L'esquire Limited

Jamirdia, Valuka, Mymensingh.

25 January 2024

2. Observations

Observation-2: Non-engineered slab opening and exposed rebar (Production Building).

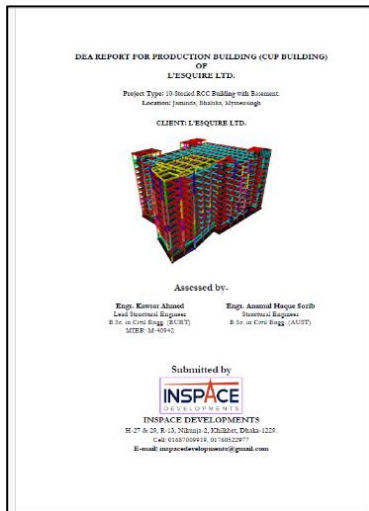
Description: During inspection, a non-engineered slab opening is observed on every floor. The building engineer is required to check the slab adequacy for the non-engineered opening at every floor and factory is required to take remedial measures for exposed rebar at slab openings.

Observation-3: Column at ground floor at loading unloading area susceptible to vehicular impact (Production Building).

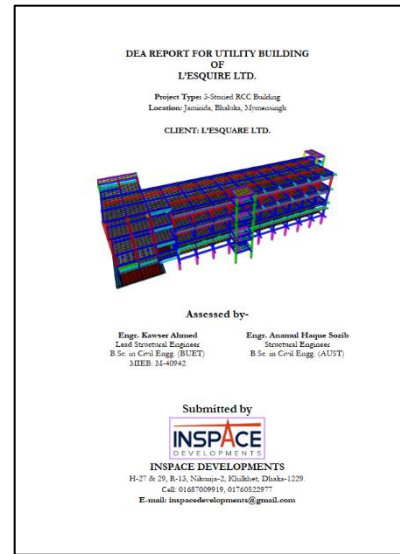
Description: During inspection, it was found that ground floor columns of Production Building at loading unloading area are susceptible to vehicular impact. Factory is required to provide adequate barriers around column at ground floor to prevent vehicular impact.

Observation-6: Improper water drainage system (Utility Building).

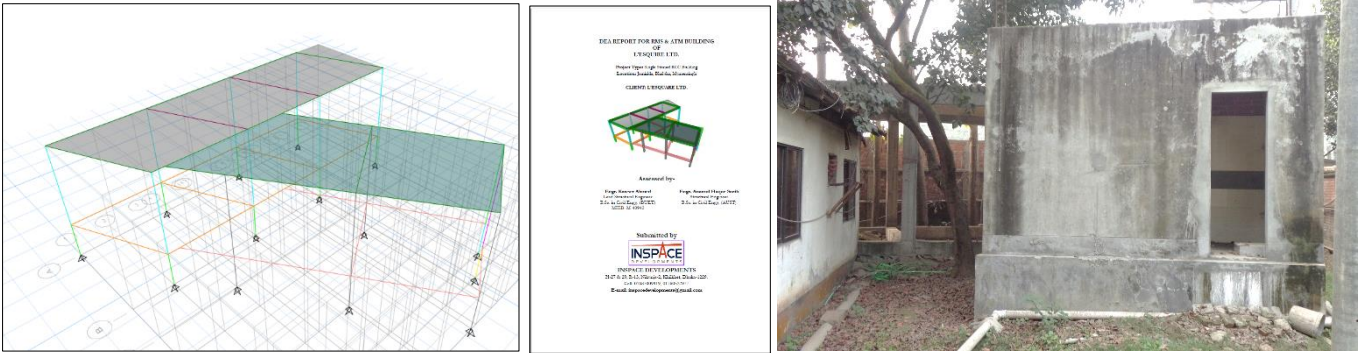
Description: During inspection, no water drainage system was observed on the roof. The building engineer is required to provide roof drainage system.
